APPLICATION NO.	FILING DATE	FIRST NAMED INVENTOR	ATTORNEY DOCKET NO.	CONFIRMATION NO.
10/786,695	02/25/2004	Neal Dulaney	35269US1	3686
116	7590	08/21/2006	EXAMINER	
PEARNE & GORDON LLP 1801 EAST 9TH STREET SUITE 1200 CLEVELAND, OH 44114-3108			VALENTI, ANDREA M	
			ART UNIT	PAPER NUMBER
			3643

Office Action Summary	Application No. 10/786,695	Applicant(s) DULANEY, NEAL	
	Examiner Andrea M. Valenti	Art Unit 3643

Claims 1-5, 9, 12, 13, 16-18 and 30-32 are rejected under 35 U.S.C. 103(a) as being unpatentable over FILTERSTAR, S/ENS:841553-01 Inlet pipe; S/ENS:841545-01 Outlet pipe; 3 pages in view of U.S. Patent No. 5,542,451 to Foster.

Inlet pipe / Aspiration / Ansaugrohr / Aanzuigbuis

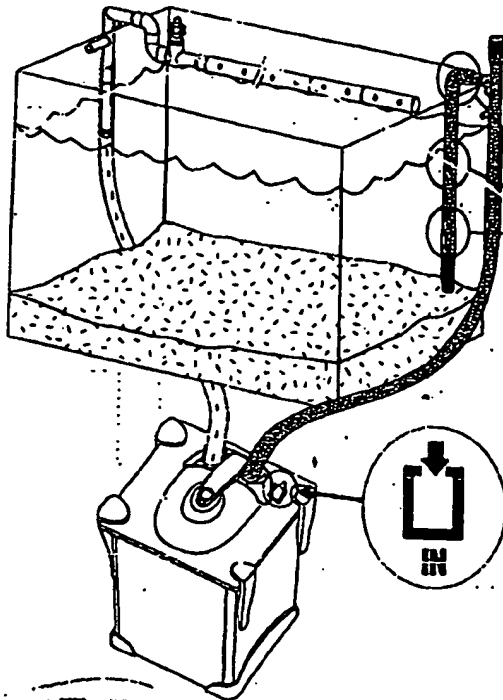
Regarding Claims 1 and 18, FILTERSTAR teaches a modular water flow system for an aquarium (FILTERSTAR page 1 and 2) comprising: a water intake system (FILTERSTAR page 1 Inlet pipe) wherein the water intake system pulls water in from the aquarium through an inlet (FILTERSTAR page 1 Inlet Pipe, shaded pipe in the Fig.) which customizably pulls water in from multiple locations of the aquarium due to a propulsive force created by the pump (FILTERSTAR page 3 teaches it is customizable and is capable of being positioned at various locations within the aquarium); a water return system (FILTERSTAR page 2 Outlet pipe) wherein the water return system permits the water to return to the aquarium from multiple outlets customizable located in multiple locations of the aquarium (FILTERSTAR page 2 Outlet pipe has multiple outlets along its length thus "multiple locations" plus the pipe can be customizable located to different sides of the aquarium page 3); at least one valve assembly (FILTERSTAR page 3 Fig. G) to manage at least one of the water return system and the water intake

Regarding Claim 30, FILTERSTAR as modified teaches the inlet portion is rotatably coupled to the interior portions of the modular water flow system to facilitate positioning of the modular water flow system (FILTERSTAR page 1 and page 3).

Outlet pipe / Reroulement / Ausgangsrohr / Urtlaaf

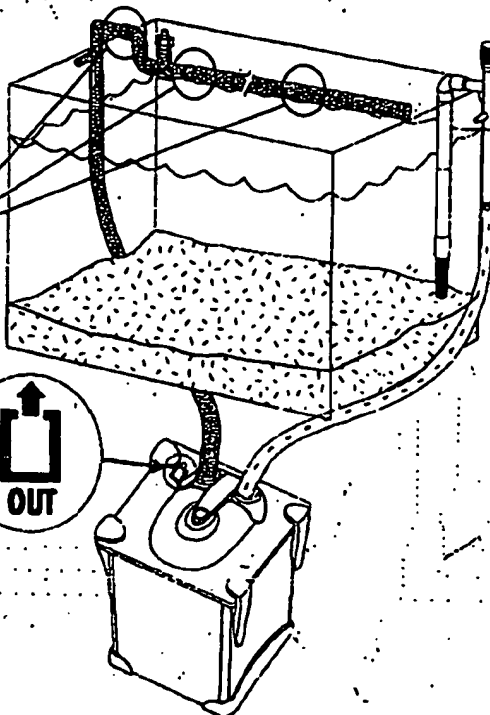
Regarding Claim 9, FILTERSTAR as modified teaches the outlet port is rotatably coupled to the corresponding exterior portion of the modular water flow system (FILTERSTAR page 3 and page 2).
